METROPOLITAN GOVERNMENT OF NASHVILLE AND DAVIDSON COUNTY

STAFF RECOMMENDATION 2414 Oakland Avenue September 19, 2012

Application: New construction – addition; Setback reduction
District: Belmont-Hillsboro Neighborhood Conservation Zoning Overlay
Council District: 18
Map and Parcel Number: 10416028100
Applicant: Blaine Bonadies, Architect
Project Lead: Sean Alexander, sean.alexander@nashville.gov

site plan/roof plan

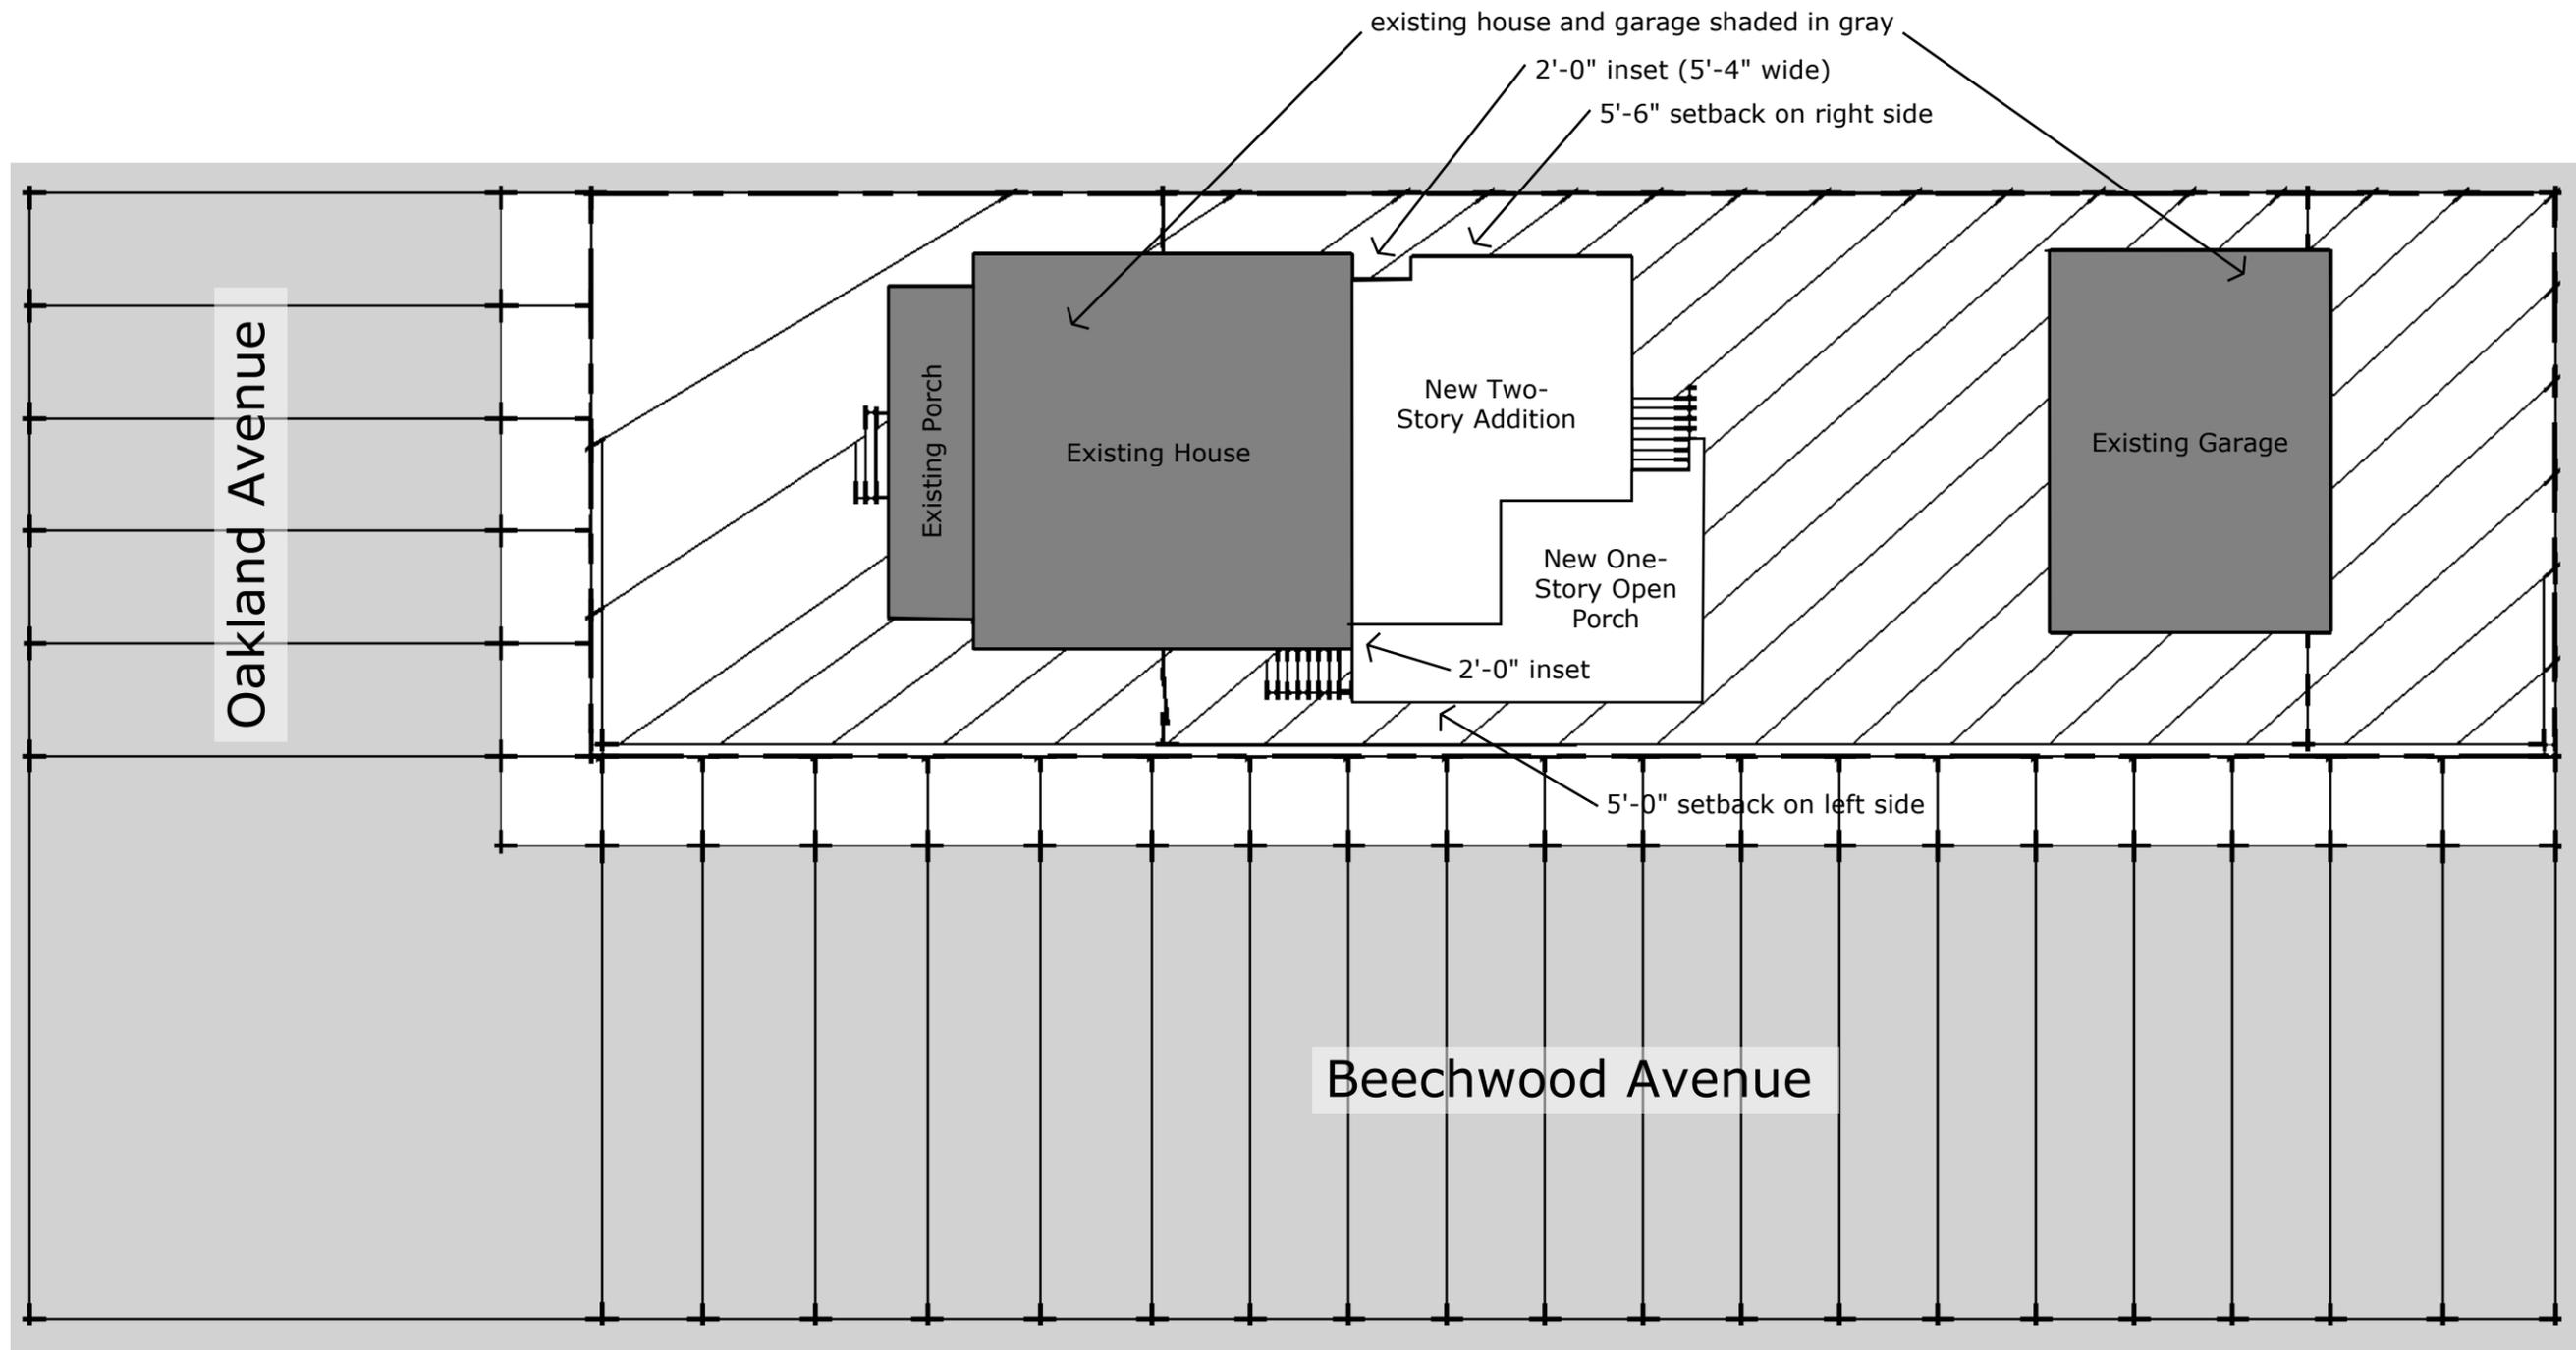
Analysis and Findings: The applicant is proposing to enlarge the structure with a two-story rear that includes a one-story porch. The porch component would require a reduction of the side setback from ten feet (10') to five feet (5').

The left side of the addition will be five feet, six inches (5'-6") from the left property line and five feet (5') from the right. Because 2414 Oakland Avenue is a corner lot, the current side setbacks are five feet (5') on the left and ten feet (10') on the right, facing Beechwood Avenue. There are a few examples of historic houses on corner lots nearby with side-street setbacks of less than ten feet (10'), but generally these are small bays or projections of less than one hundred square feet (100' sq. ft.). Staff could not locate any historic houses with an addition protruding from the sidewall of the house and encroaching into the side setback buffer. For this reason, staff concludes that the side portion of the one-story porch does not meet guidelines II.B.1.c and II.B.2.a, and that the requested setback reduction for the porch would not be appropriate.

Side additions are not appropriate, in this case, since the lot is not more than sixty-feet (60') in width. To maintain the required two foot (2') inset for additions and to eliminate the need for the side setback, staff recommends the side portion of the porch be eliminated and the porch only extend to the rear of the addition. With this condition, the location of the addition maintains the rhythm of spacing between buildings established by surrounding historic houses. It also meets the setbacks required by the zoning code.

- Staff approve final details of windows and doors;
- The porch only extend off the rear of the addition and not the side of the addition, thereby not requiring a setback reduction and keeping the required two foot (2') inset;
- At least one window take the place of the door that currently is proposed to lead to the side of the porch; and,
- The applicant submit new drawings with major measurements called out.

right side elevation

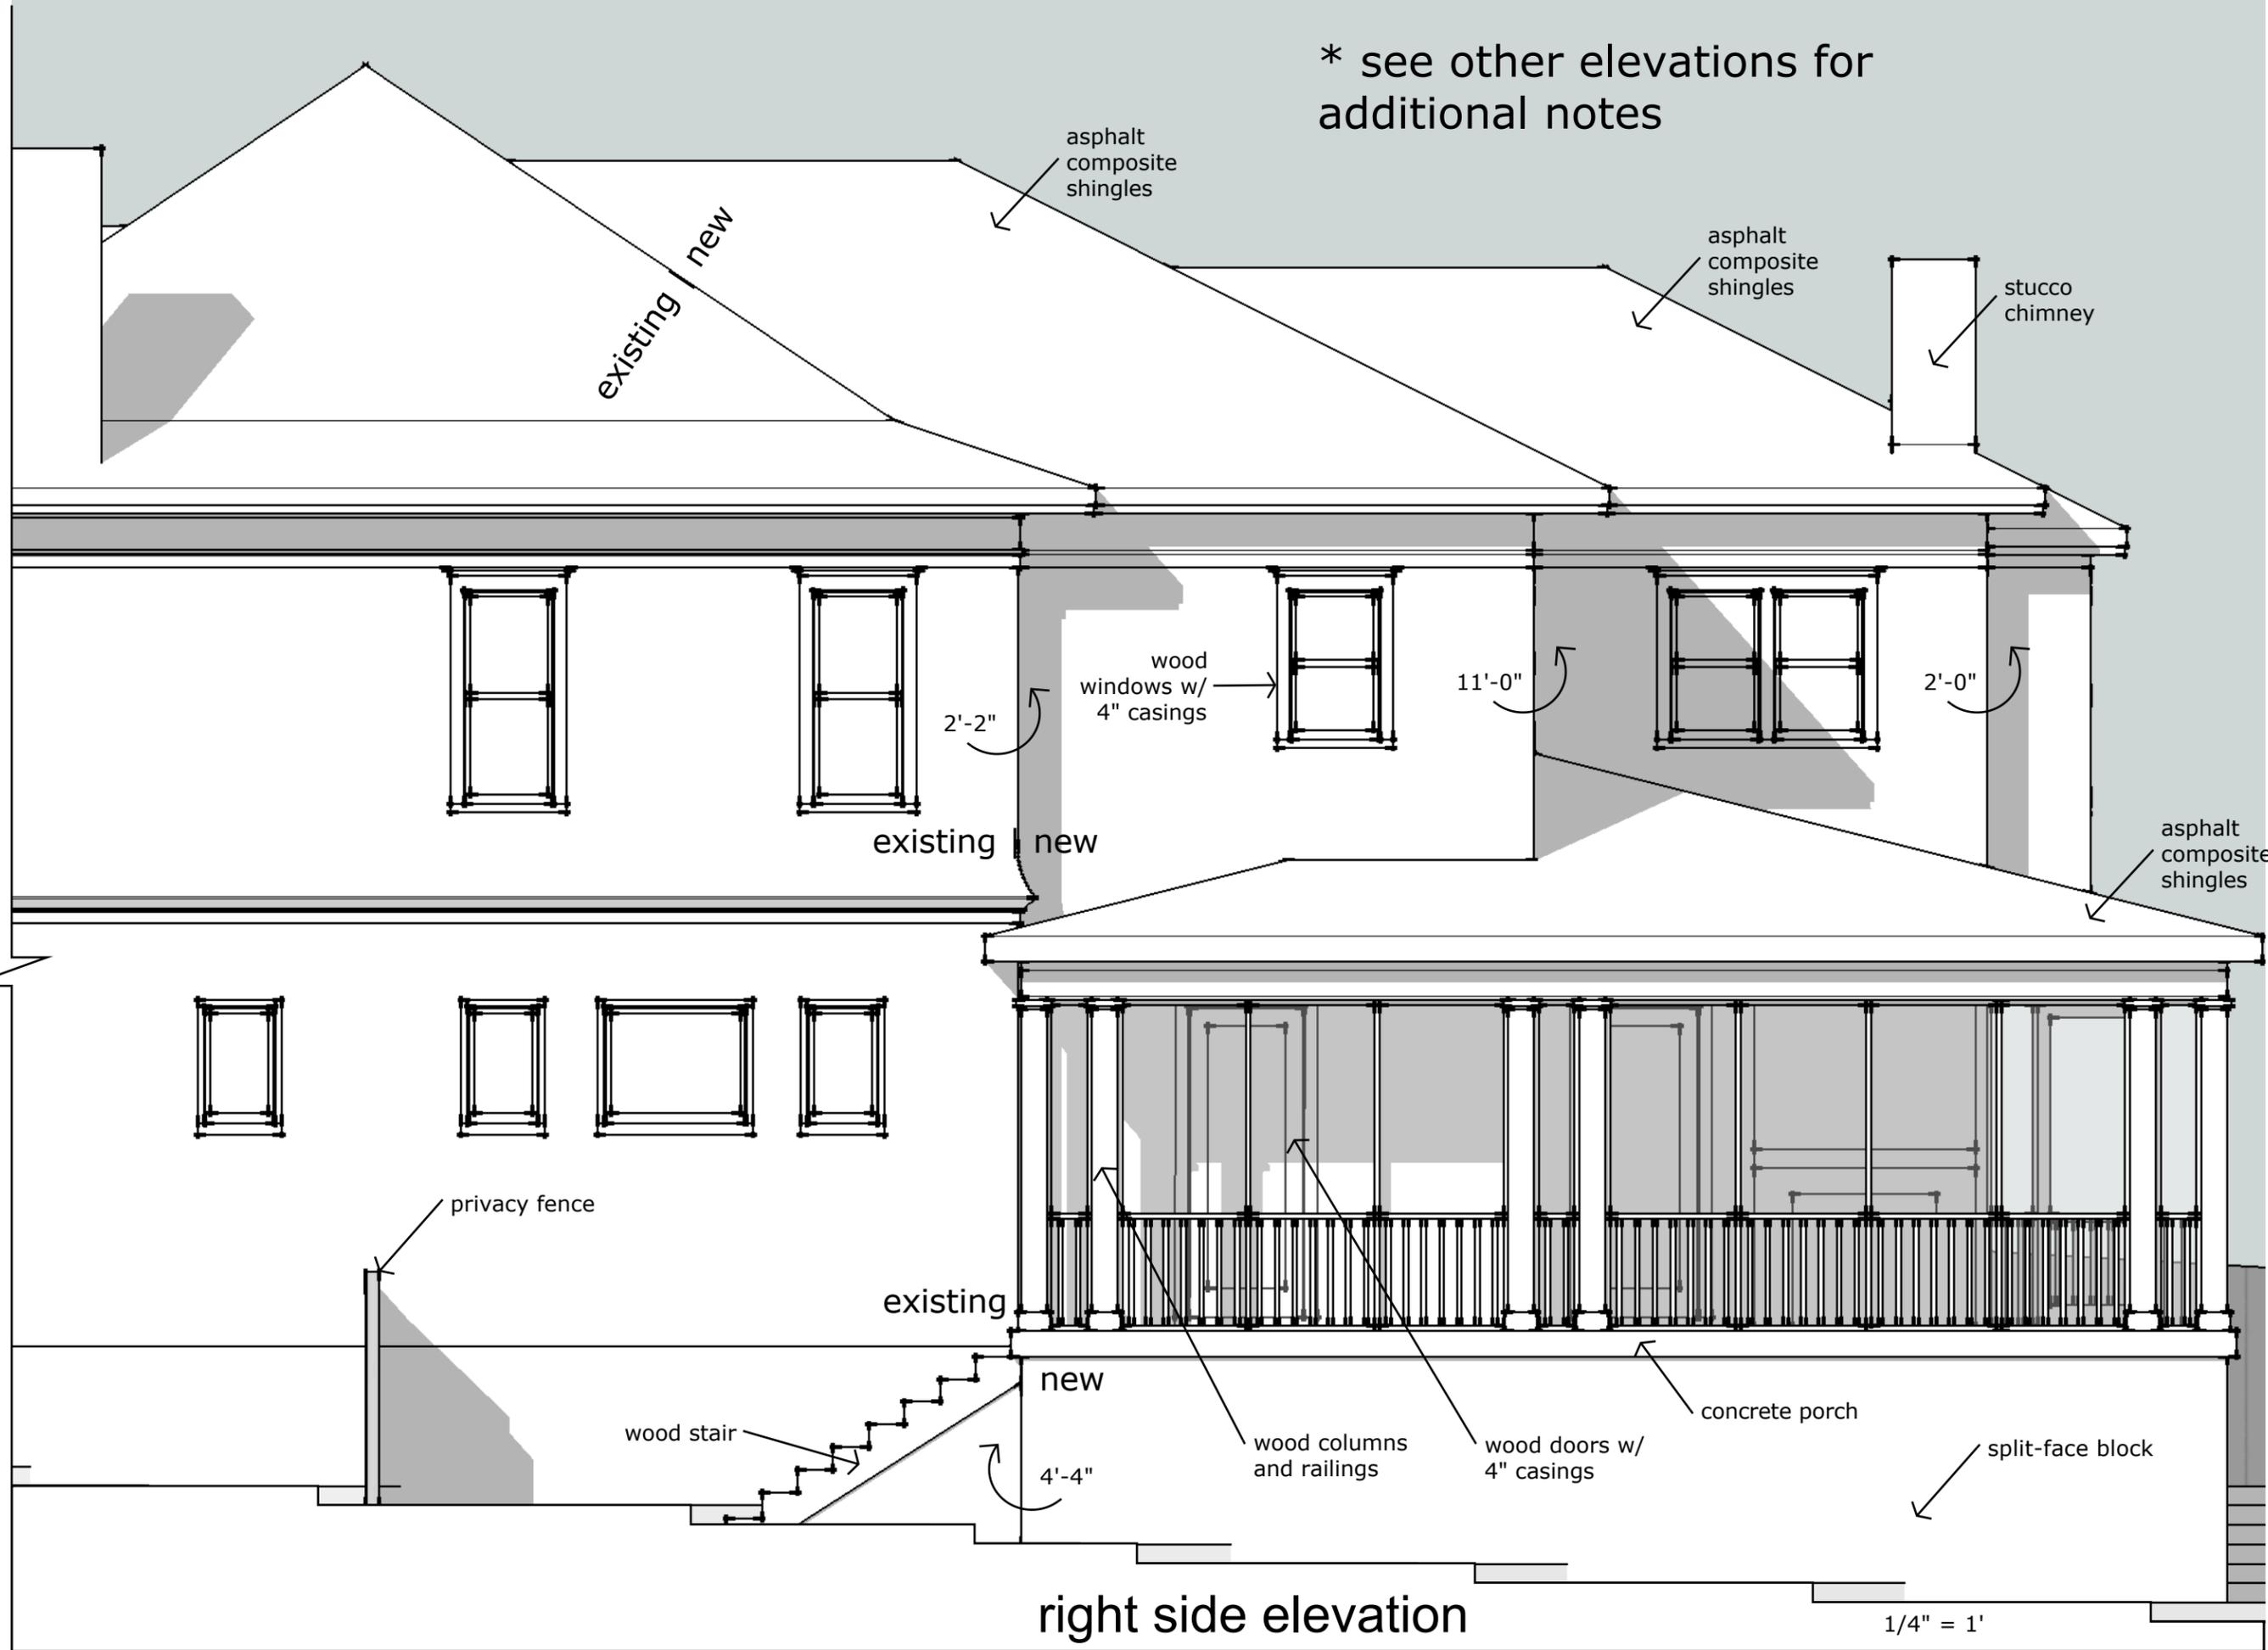
The left wall of the addition will step in two feet (2') from the historic house, carry back five feet (5'), and then step back in line with the wall of the house for another twenty feet (20'). The right side is proposed to step out approximately seven feet (7') from the side. The footprint of the two-story addition, not including the proposed porch, will have a footprint of six-hundred, seventy-five square feet (675 sq. ft.). The porch will have a hipped roof, tying into the side and rear of the two-story addition, with an eave height one foot (1') below the beltcourse at the second floor level of the historic house.
